**Marion County  
Board of County Commissioners**

**PLANNING & ZONING SECTION  
STAFF REPORT**

<b>P&amp;ZC Date: 7/29/2024</b>	<b>BCC Date: 8/20/2024</b>
<b>Case Number:</b>	240815ZP	
<b>CDP-AR:</b>	31750	
<b>Type of Case:</b>	<b>Rezoning</b> from Planned Unit Development (PUD) to PUD to modify the unit type of 82 residential units from townhomes to single-family on a previously approved PUD for Whisper Woods.	
<b>Owner</b>	Armstrong Land, LLC	
<b>Applicant</b>	Tillman & Associates Engineering, LLC	
<b>Street Address</b>	No address assigned	
<b>Parcel Number</b>	9007-0000-12	
<b>Property Size</b>	±10.33 acres	
<b>Future Land Use</b>	High Residential (HR)	
<b>Zoning Classification</b>	PUD	
<b>Overlay Zone/Scenic Area</b>	Primary Springs Protection Zone	
<b>Staff Recommendation</b>	<b>APPROVAL WITH CONDITIONS</b>	
<b>P&amp;ZC Recommendation</b>	<b>APPROVAL WITH CONDITIONS</b>	
<b>Project Planner</b>	Eryn Mertens, JD, Planner II	
<b>Developer's Agreement</b>	None	
<b>Related Case(s)</b>	221111ZP, 211006ZP, 051010ZC

### Figure 2 Conceptual Plan

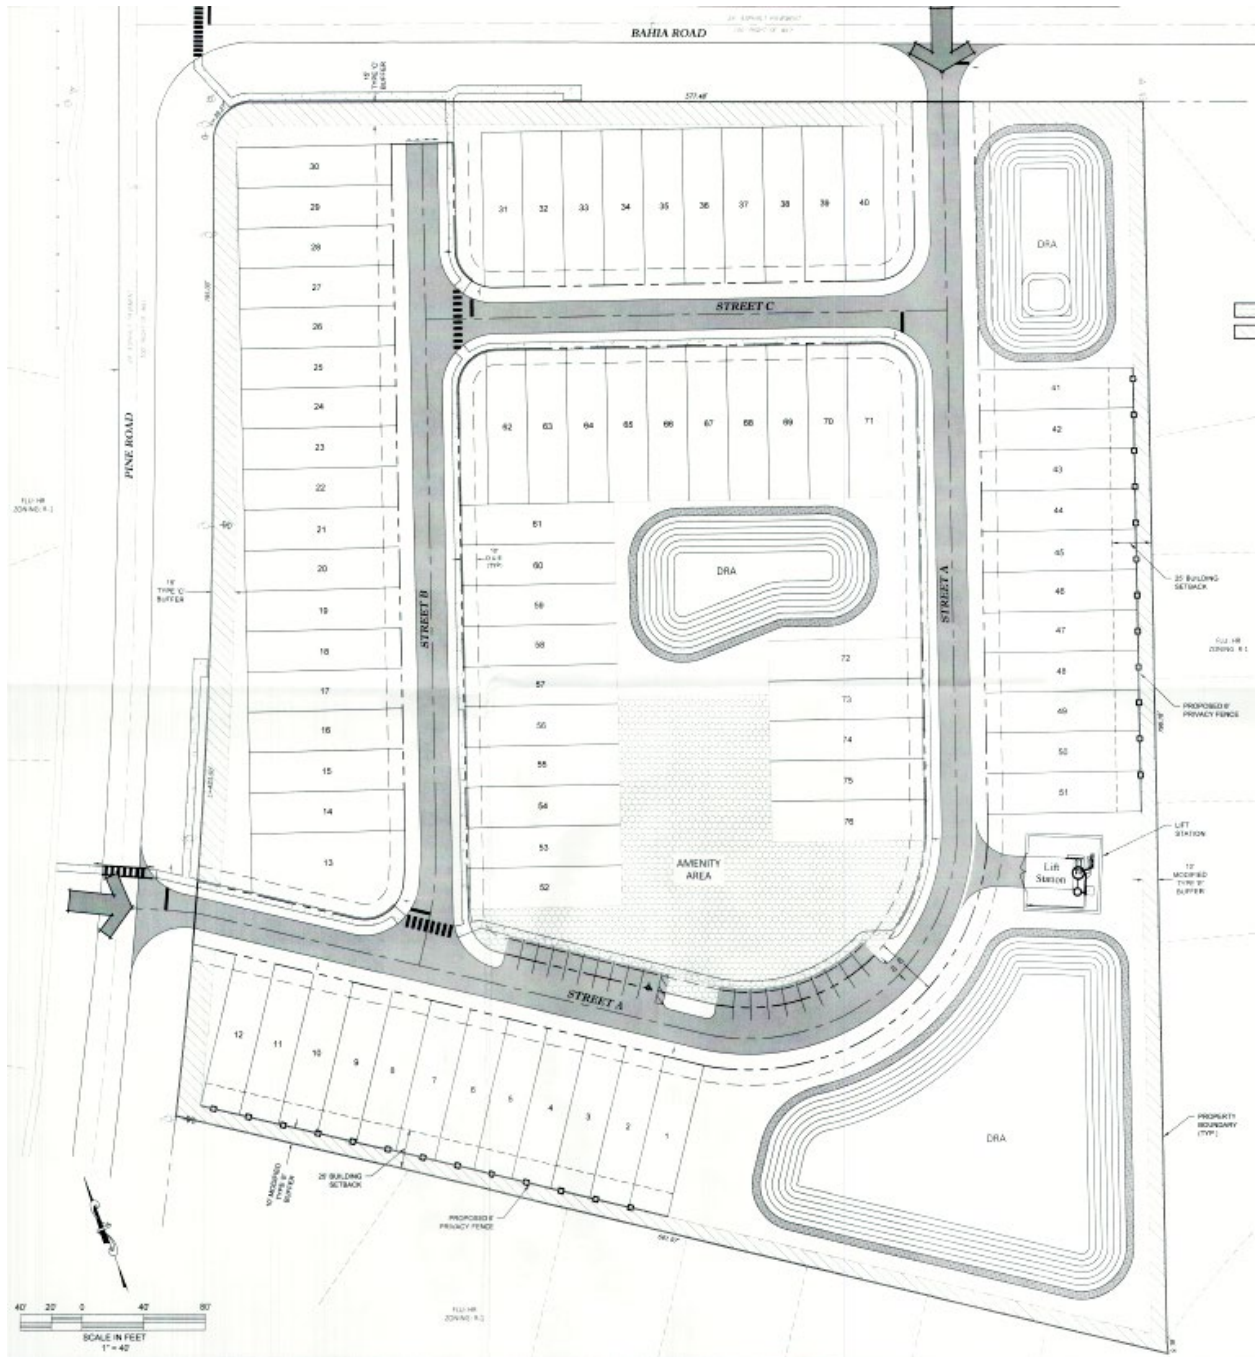
4.2.31 on Planned Unit Development. The PUD proposes a maximum of 82 detached single-family residential units (see Attachment A). Please note that while the Concept Plan only shows 76 lots, the PUD was originally approved for 82 units (see Attachment B). The overall proposed density for the PUD, with 82 detached single-family units, remains unchanged at 7.9 dwelling units per acre. The PUD proposes maximum building height of 40', and the architectural renderings depict two-story units. Lot typicals can be found in Attachment B, and propose 26' interior lot widths and a minimum width of 48' for the corner lots. The PUD proposes approximately 2.9 acres of open space, and within that open space is a playground, which must be installed prior to the issuance of the 35<sup>th</sup> certificate of occupancy. Figure 2 (also found in Attachment B) below shows the proposed conceptual plan. Figure 3 below shows the currently approved PUD conceptual plan.

**Analysis:** Staff finds that the subject property is 10.33 acres in size with High Residential FLUMS. The High Residential FLUMS allows for 4-8 dwelling units per acre. The subject property, by FLUMs, allows for a minimum of 41 dwelling units and a maximum of 82 dwelling units. The proposed 82 dwelling units is 100% of the maximum residential development allowed by the FLUMs of the subject property. The proposed density of the PUD is 7.94 dwelling units per acre. The proposed PUD **is consistent with this section**. Please note, however, that the Concept Plan submitted with this request only depicts 76 units.

- The PUD is restricted to a total of 82 detached single-family dwelling units, and accompanying accessory amenities consistent with the Marion County Land Development Code, the PUD Application, and PUD Concept Plan (Dated 5/2024; attached).

**Figure 4**  
**Prior PUD Modification (221111ZP)**  
**Concept Plan as submitted with application**

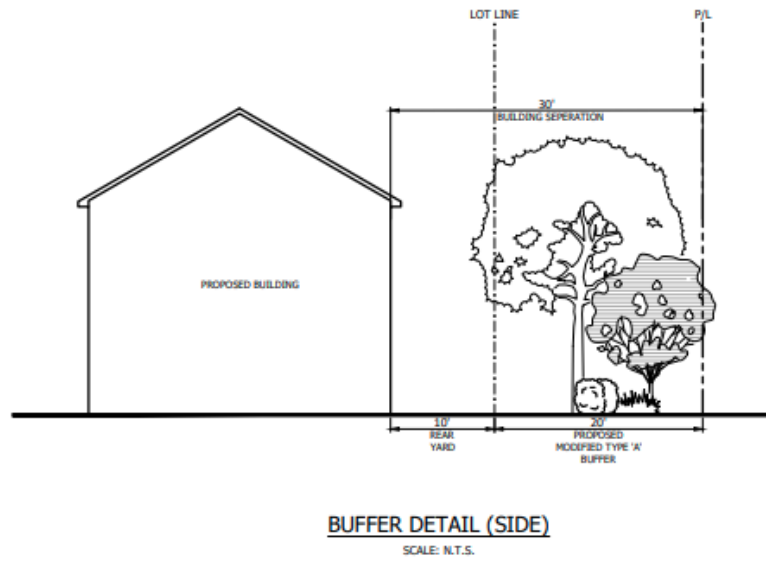
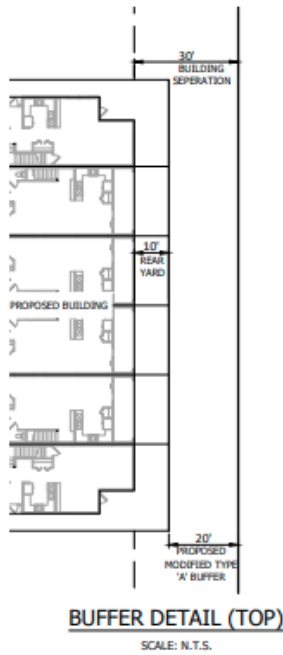
Upon closer inspection of this Concept Plan, along the southeast border of the project, there are 11 proposed lots. The Concept Plan labels the setback from the building to the property line, rather than the lot line of each home, and that total distance is 25'. Inside this 25' is a 10' landscape strip with a 6' fence. This places the PUD home buildings 15' away from the buffer.

Of note, the last approved PUD required a modified Type-A buffer consisting of 20' with a minimum of 2 shade trees and 5 understory (ornamental) per 100 lineal feet with shrubs and groundcover (which under a PUD may be clustered and not evenly-spaced), and a minimum of a 4-foot high decorative fence barrier along the interior boundary of the Type A Buffer. The resolution specifically mentions the intent of this buffer is to deter access and prevent encroachment into the minimum 20' wide planted buffer. See Figure 4.

**Figure 5**  
**Proposed Modified Type E Buffer for eastern and southern boundaries and a 6' opaque fence behind the homes**

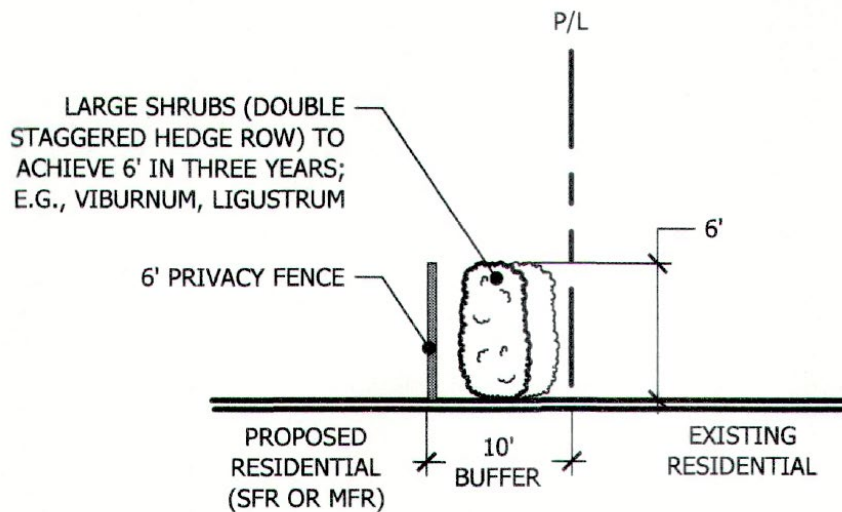
However, along the southeast and southwest boundaries (sharing property lines with the existing surrounding single-family homes), the applicant is **now proposing a Modified Type E buffer (10' wide landscape strip with a 6' privacy fence**; made up of **shrubs** to be planted in a double staggered row and be capable of reaching a **maintained height of 6' within 3 years, no groundcovers used**). From the proposed residential buildings, there is 15' of yard space to the lot line, and then the 10' wide landscape strip is from the lot line to the project boundary/beginning of the neighboring property.

While 6' shrubs, if well maintained, provides a more pleasing aesthetic and effective visual screen from one-story home to one-story home, it does little to visually screen between two-story to one-story homes, even with a 6' privacy fence, especially with the PUD homes being so close to the property boundary (25'). Further, with 26' wide lots, the existing homes along the southeast and southwest boundary of this project could potentially have up to 4 of these two-story PUD homes backing up to their property line.

Staff finds that the application **fails to meet** the requirements within this section, as it fails to comply with the minimum requirements established in the Code, and it also fails to meet the intent of the Code by alternative means. This proposed alternative design, also fails to include, at a minimum, scaled typical vertical and horizontal cross-sections of the buffer, including depictions of all proposed alternative buffer improvements and scaled representations of the existing principal structures and improvements that are located on the adjoining properties being buffered from the PUD. Finally, the new proposed buffers also fail to meet the intent of the existing requirements as stated in the Resolution (i.e., it is silent as to the measures taken to prevent encroachment into the buffer by the PUD property owners, which was specifically called out in the existing requirements).

**Staff does not support the requested buffer design change**, thereby recommending to leave the existing Modified Type A Buffer requirements in place along the southeast and southwest boundaries.

- Buffers shall remain unchanged from the existing buffer requirements for this PUD. See Resolution 22-R-577.

**Figure 6**  
**Project Snippet**

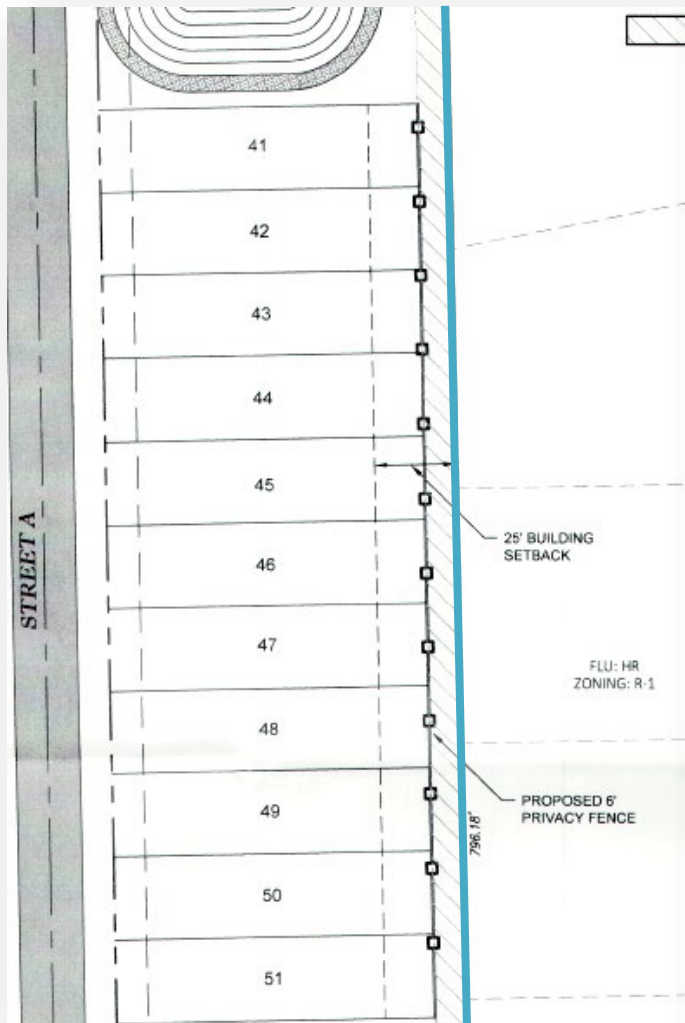
The lots proposed inside the PUD are 26' wide lots. Looking at one of the neighboring single-family homes, potentially 4 PUD single-family units would border the rear of an adjacent existing home. See Figure 6 (a snippet of the Concept Plan on the southeast border of the project), and Figure 7, a snippet of the aerial of the same area, here, where the light blue line represents the same border in each figure:

While this request is seeking to increase the height of the currently-required decorative fence, 2 additional feet on the height of the fence does not fully address the inconsistency in types of residences between the established homes bordering this PUD and the proposed project, especially with the lesser intense buffer proposed in this modification application.
